**GM SERVICE AND PARTS OPERATIONS  
DCS1749  
URGENT - DISTRIBUTE IMMEDIATELY**

Subject: 06217 – Noncompliance Recall  
Head Impact Protection

Models: 2005-2006 Chevrolet Cobalt Coupe  
Without Roof-Mounted Side Impact Airbags

## FMVSS NONCOMPLIANCE RECALL

1883691

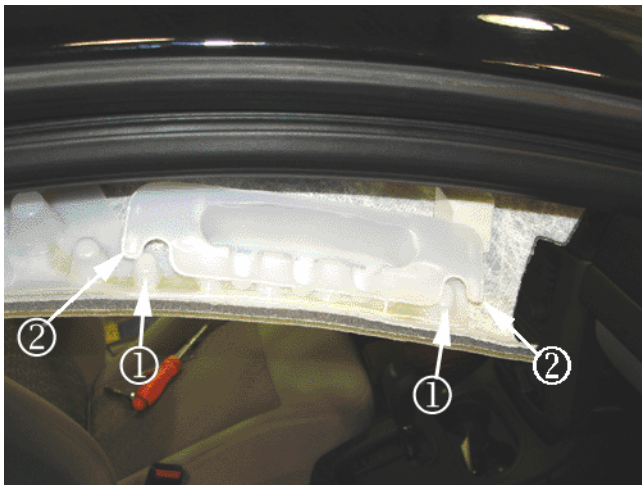
**Important:** The headliner will drop about 203 mm (8 in), which will provide adequate room to install the insert energy absorbing (EA) plastic piece into the headliner. Use GM Care Hot Melt Adhesive Sticks (P/N 12377914) or equivalent to glue the EA plastic piece into the headliner.

5. Locate the installation anchor points (2) for installing the energy absorbing (EA) plastic piece (3) onto the headliner (1).
